**SECTION 00 90 03
BIDDING AND CONTRACT REQUIREMENTS
ADDENDUM NUMBER 3**

Issued: November 7, 2024

**McHenry County College
2024 Renovations – Bid Package 2**
Architect's Project Number: 24-013

ED1.20

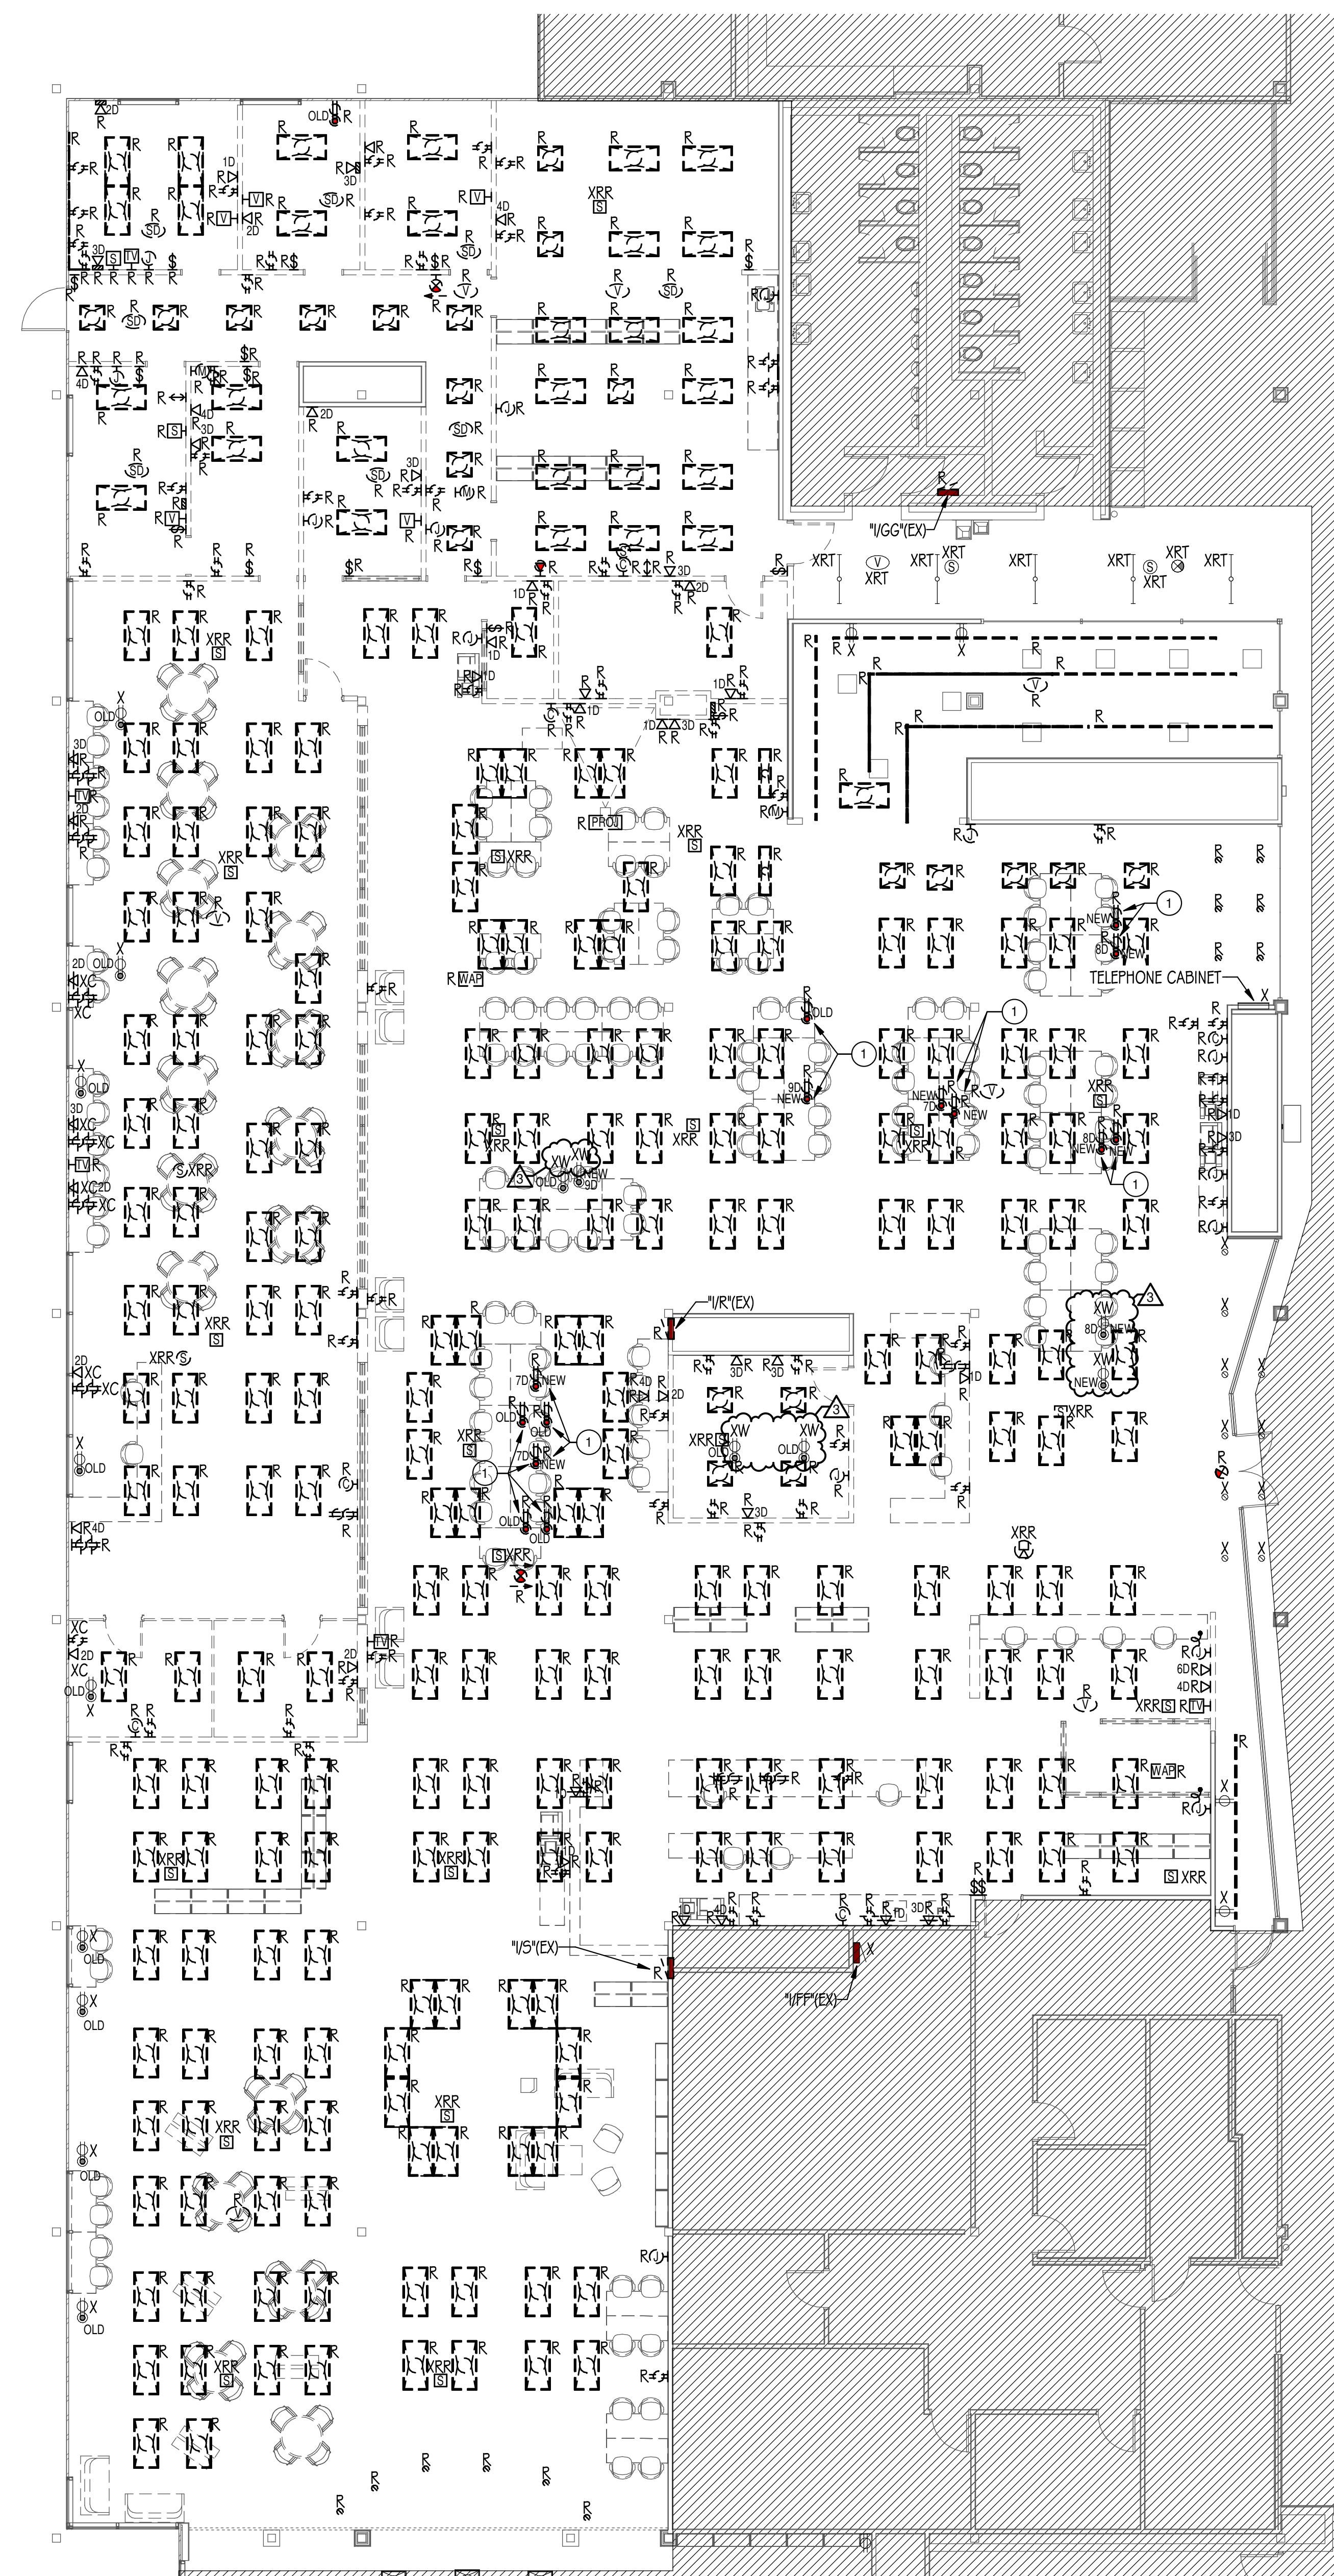
1. ED1.20
 - A. **REVISE** demolition tag for existing floor boxes to remain in Library area to be 'XW' in lieu of 'X'.
2. E0.10
 - A. **ADD** callout tags for area of work.

E0.12

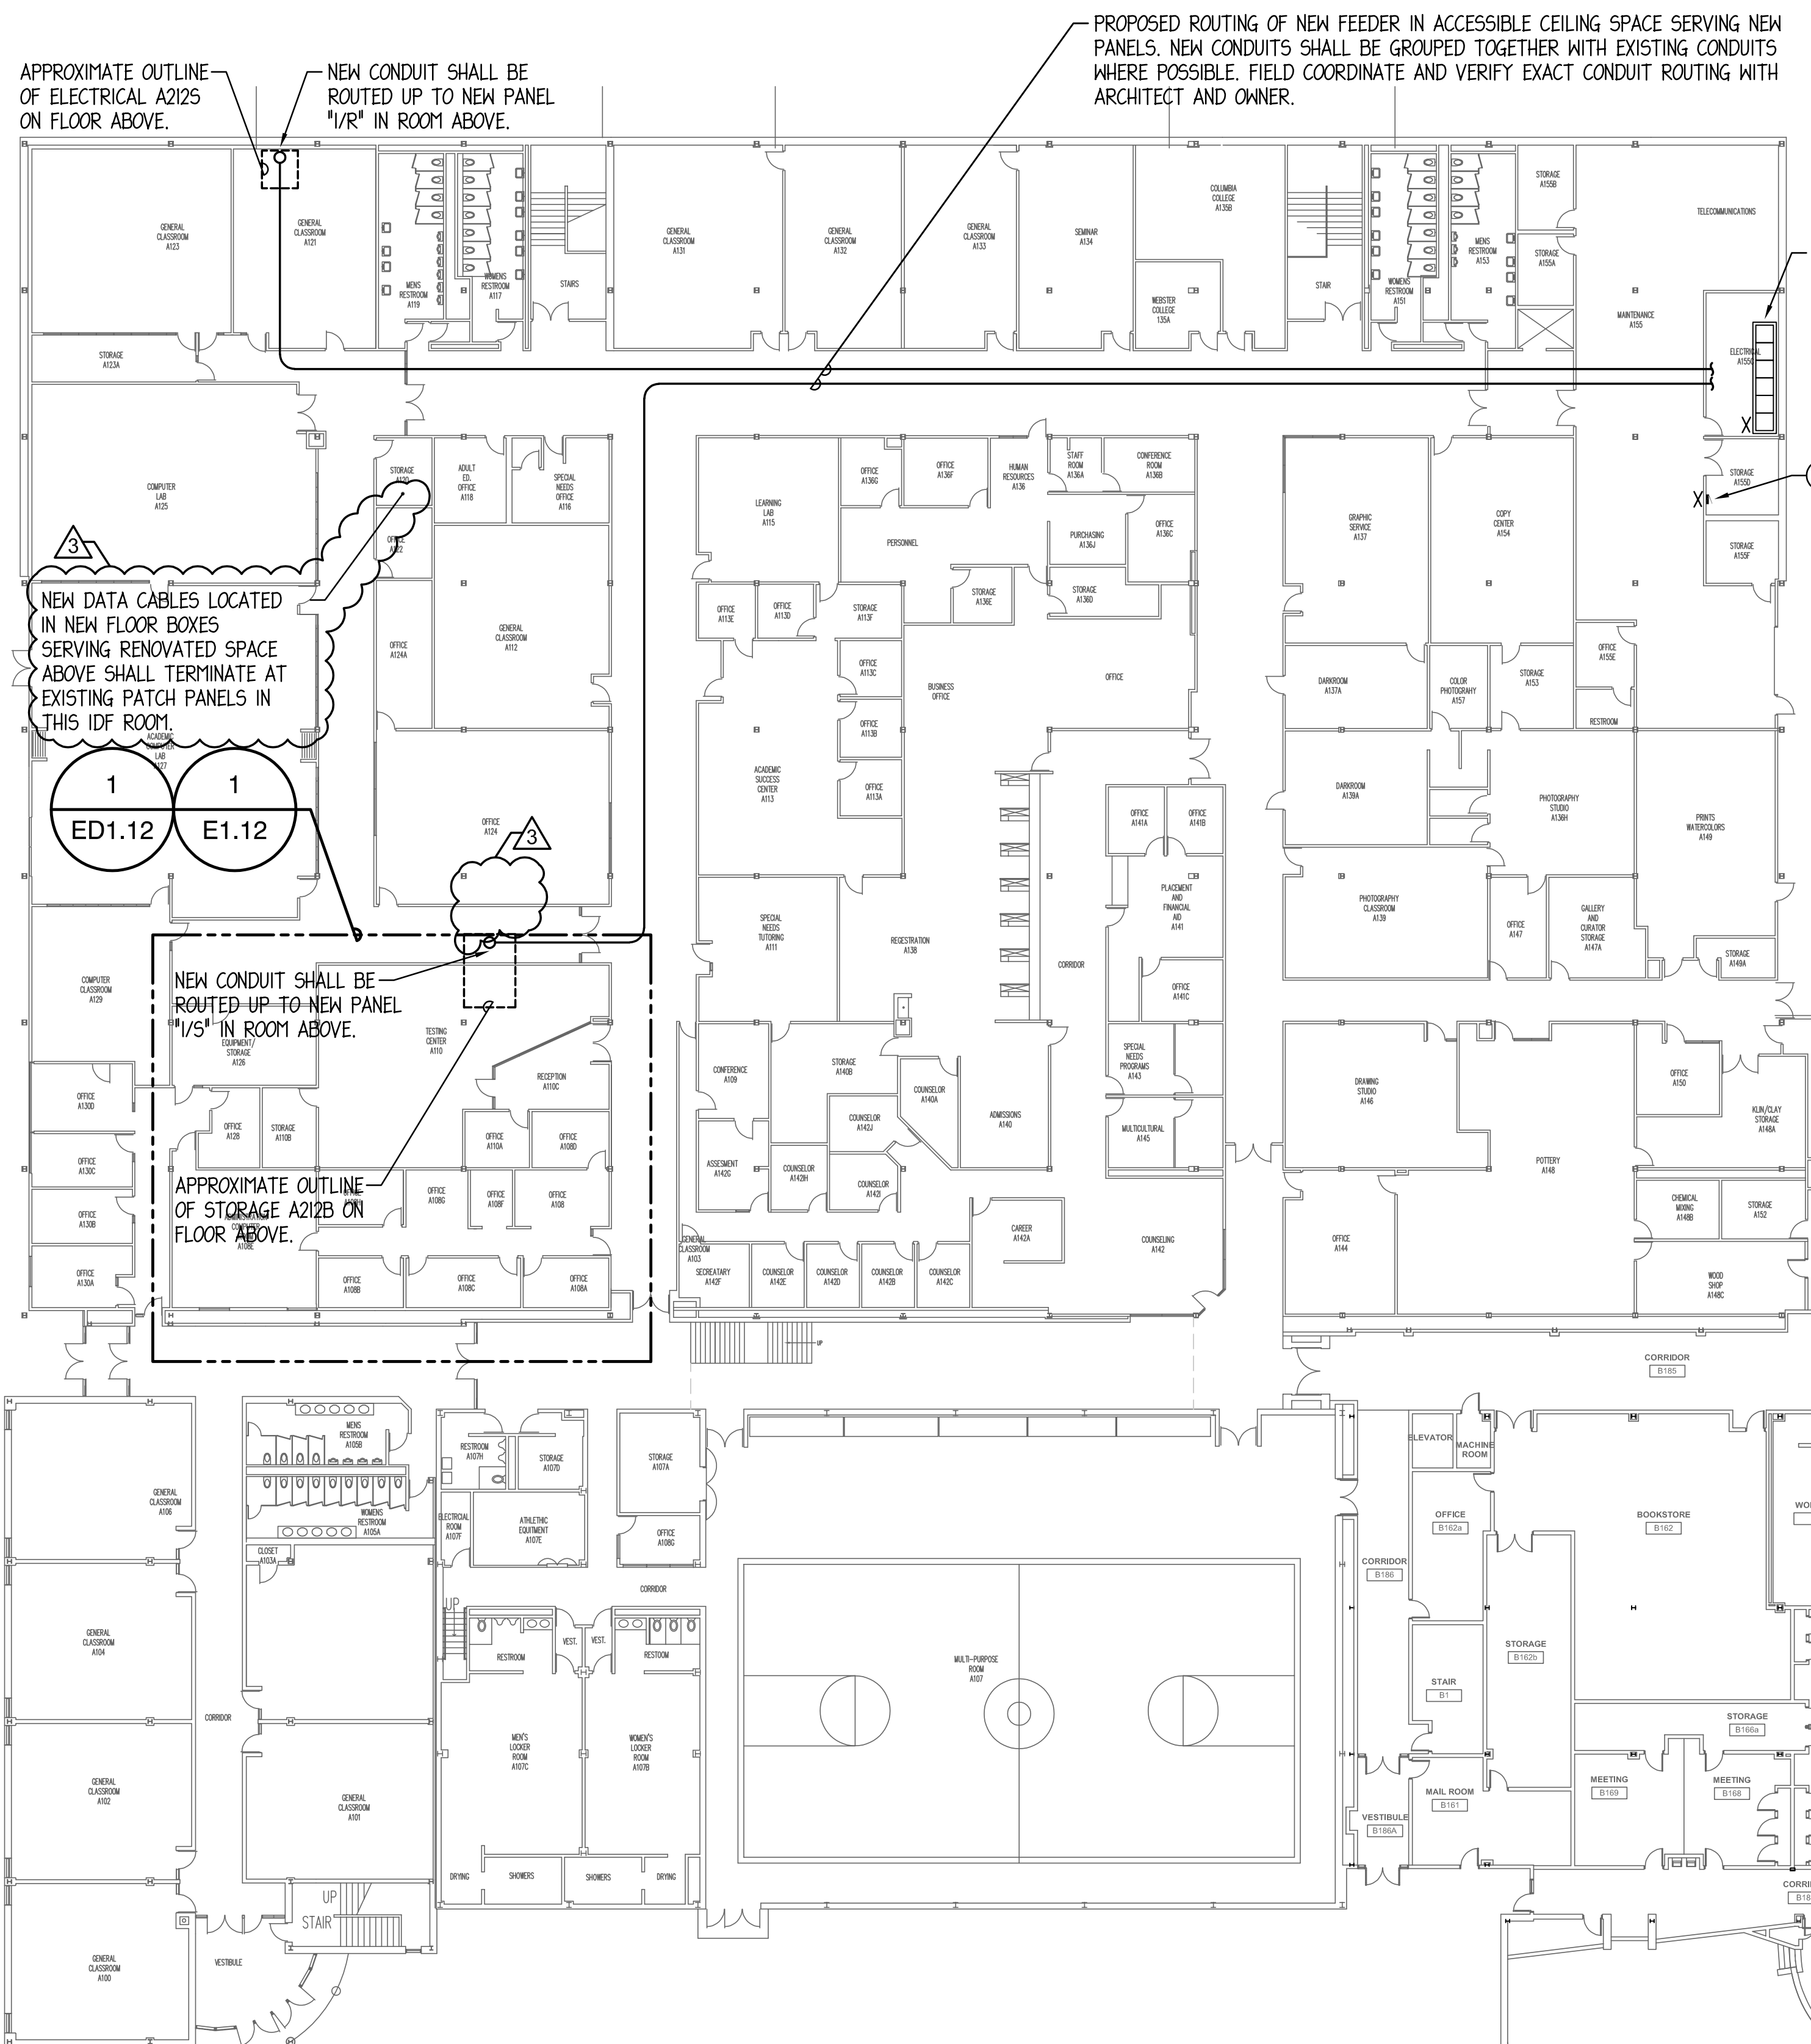
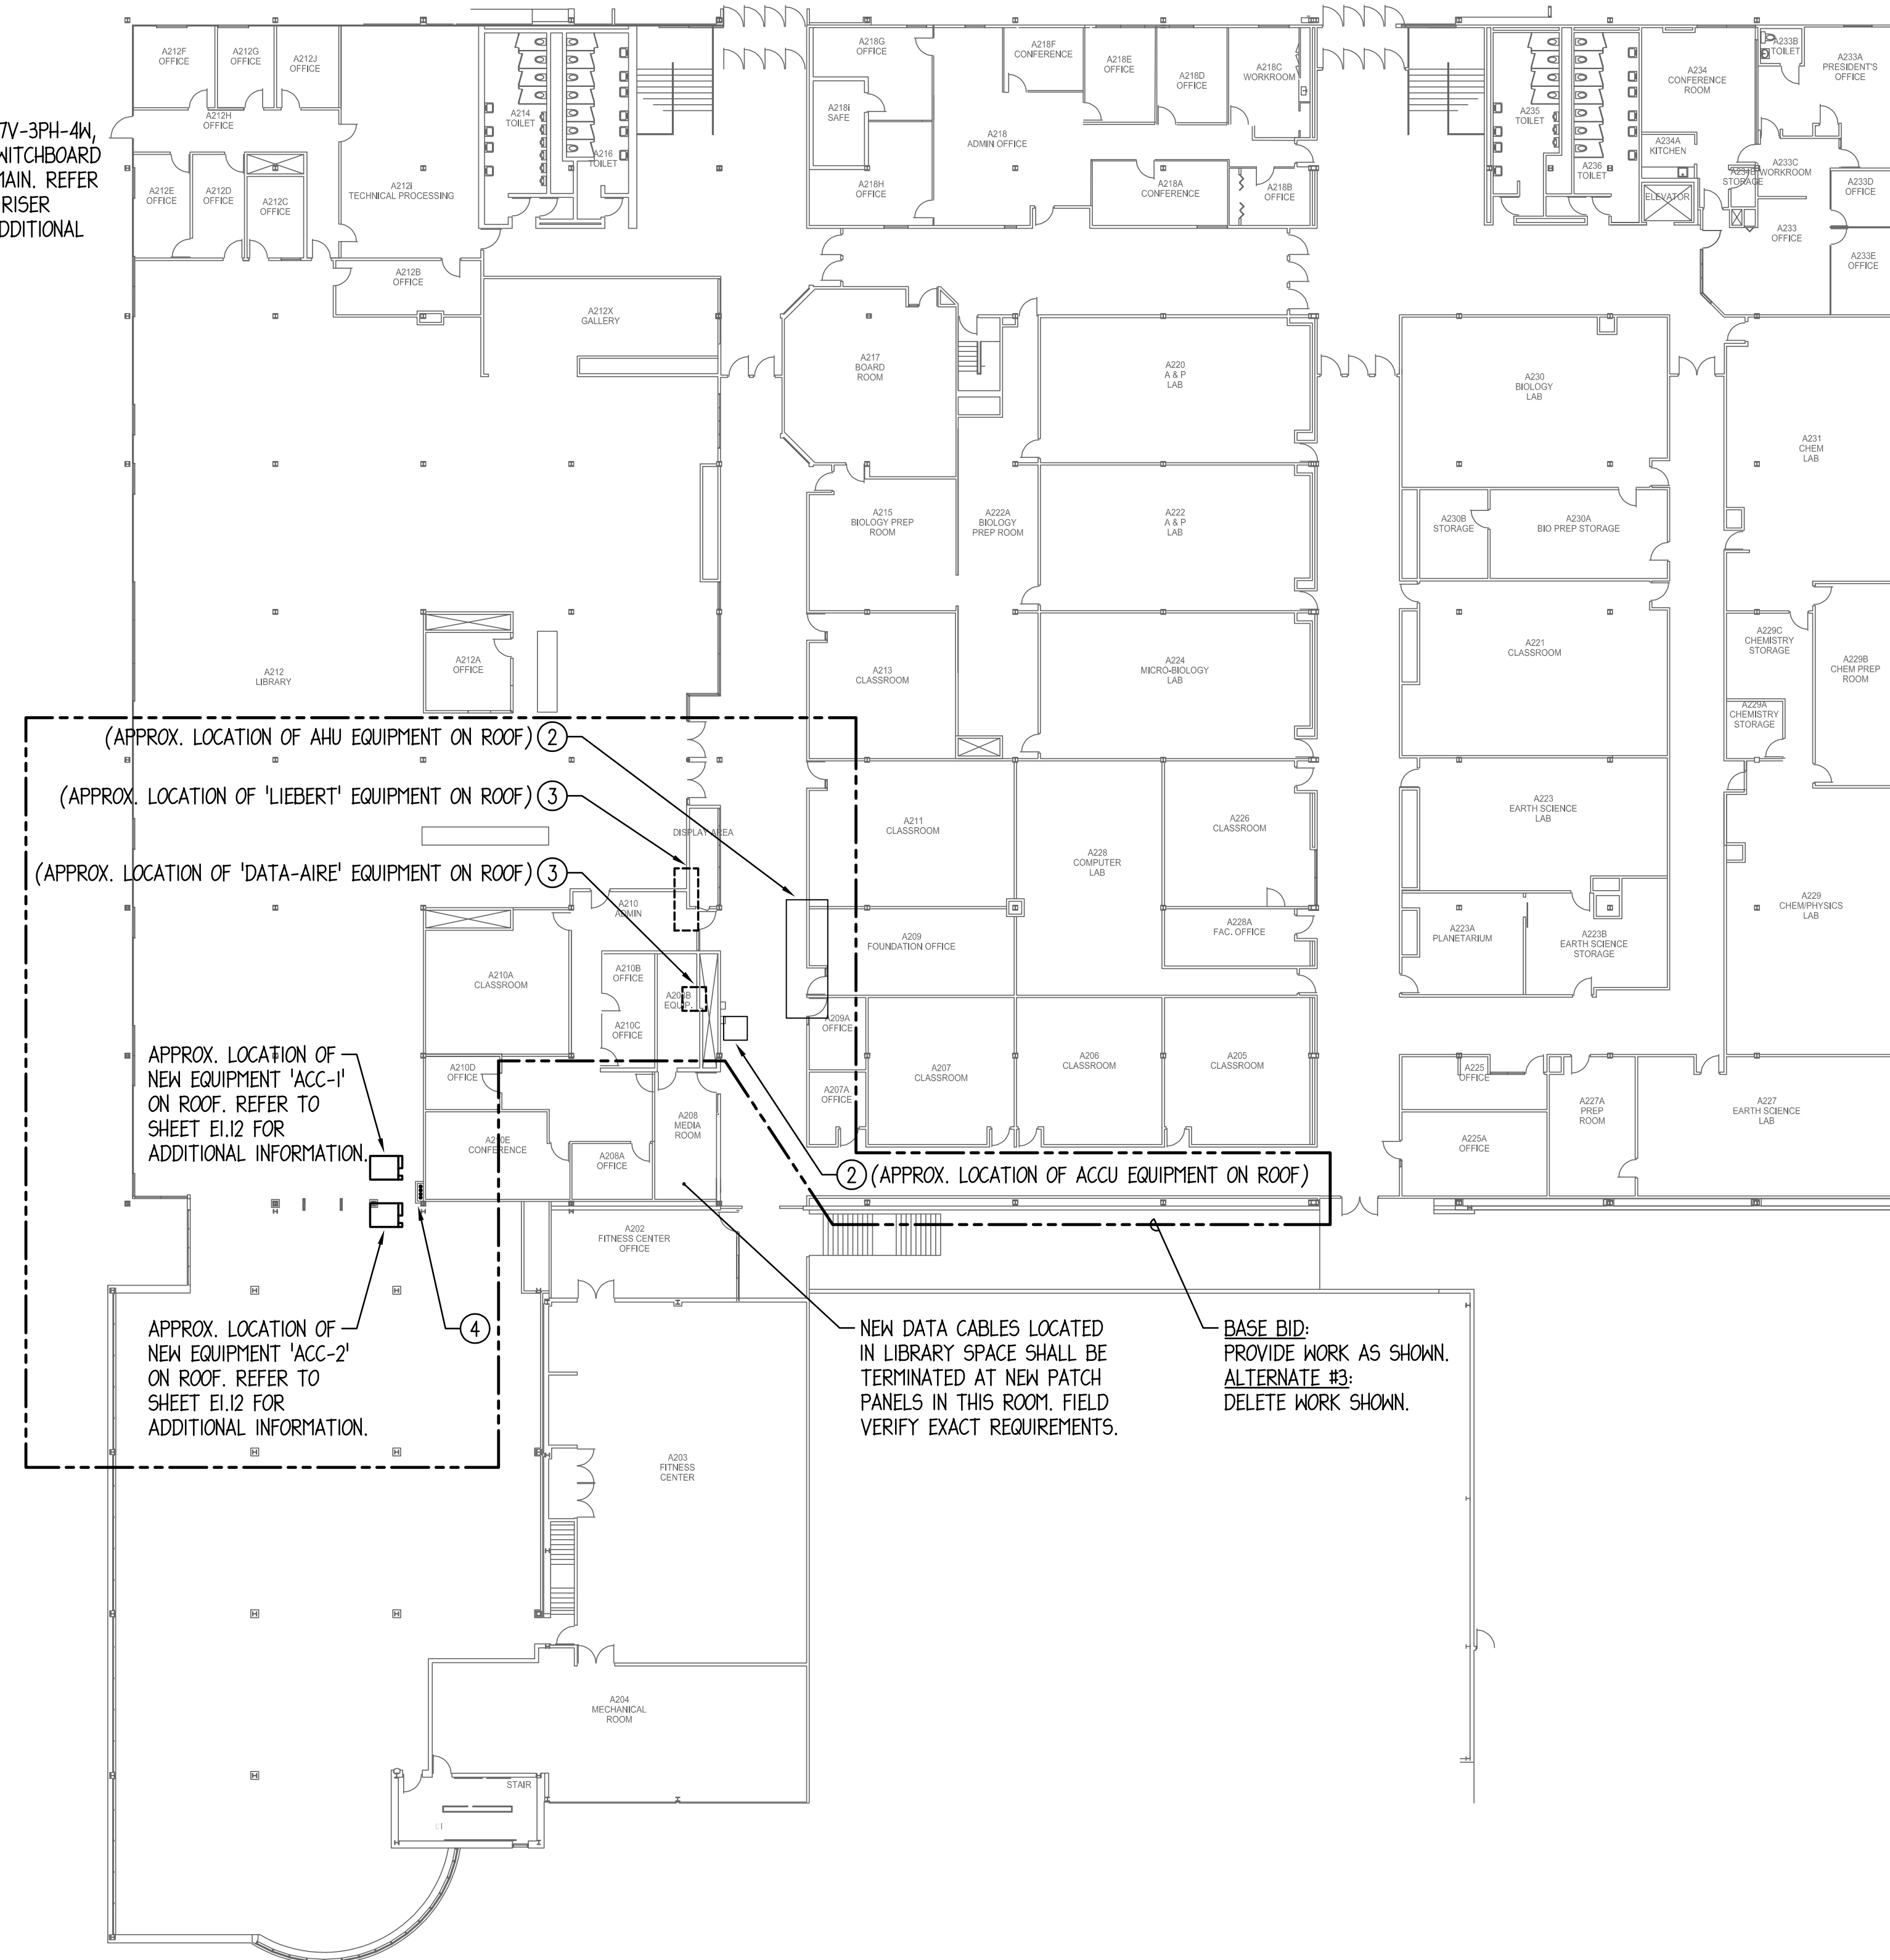
3. E0.12
 - A. **DELETE** conduit sleeve up to the upper floor and associated drawing note #5 outside Testing Center A110.
 - B. **ADD** location of existing IDF at Storage A120 and associated note.
